Project	IEEE 802.16 Broadband Wireless Access Working Group < http://ieee802.org/16 >
Title	CR on SDD Section 17: Multi-carrier Operation for Femtocell
Date Submitted	2009-2-26
Source(s)	Motoki Morita, Nader Zein, Linghang Fan, Tetsu Ikeda, Andreas Maeder, Amir Khojastepour, Mohammad Madihian NEC E-mail: m-morita@bx.jp.nec.com
Re:	Change request to Project 802.16m System Description Document (SDD) (IEEE 802.16m-08/003r7)
Abstract	This contribution proposes a scheme allowing multi-carrier operation for femtocell.
Purpose	To be discussed and adopted by TGM for use in the IEEE 802.16m SDD
Notice	<i>This document does not represent the agreed views of the IEEE 802.16 Working Group or any of its subgroups. It represents only the views of the participants listed in the "Source(s)" field above. It is offered as a basis for discussion. It is not binding on the contributor(s), who reserve(s) the right to add, amend or withdraw material contained herein.</i>

Multi-carrier Operation for Femtocell

Figure 2 Illustration of the scenario that Interference increase in multi-carrier operation for Femtocell

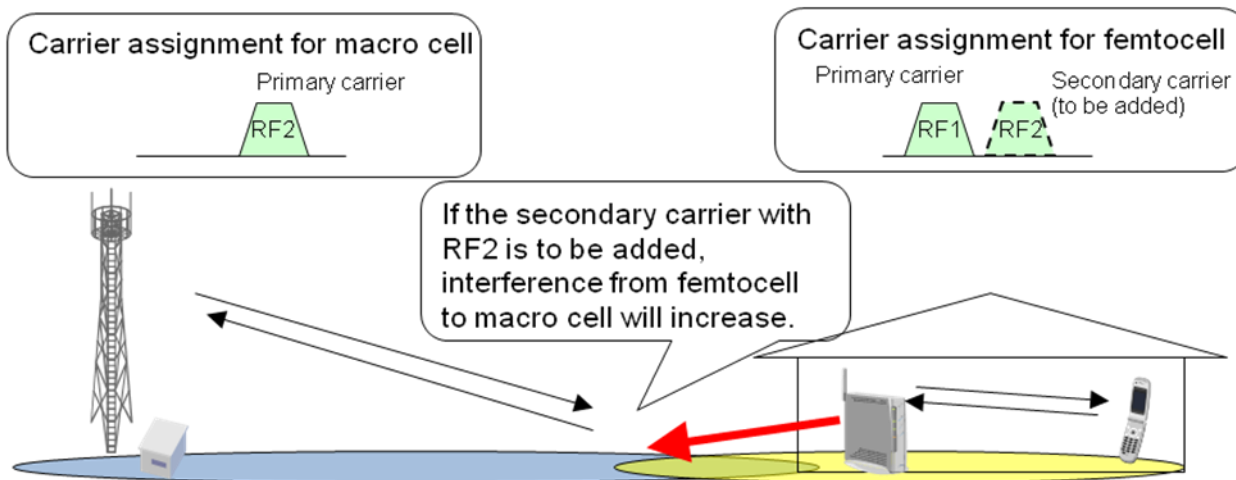
In case of multi-carrier operation for femtocell BS, the highest priority should be avoiding increase of interference on macro cell rather than adding the secondary carrier.

Figure 3 Proposal for interference mitigation in assigning the secondary carrier

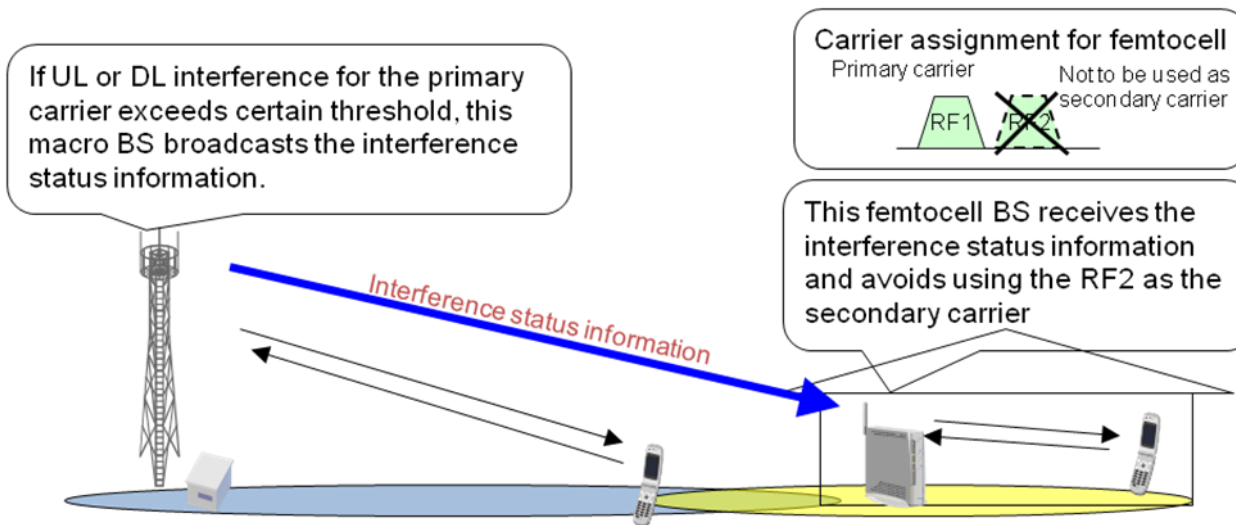
1. Macro BSs measure UL or DL interference for each carrier.
2. If the interference for a carrier exceeds certain threshold, the macro BS broadcasts interference status information which prohibits the use of this carrier as the secondary carrier to femtocell BSs overlapping the macro cell via SFH or backhaul.
3. The femtocell BSs receive the reported information and avoid using this carrier which are indicated by the macro BS as the secondary carrier.
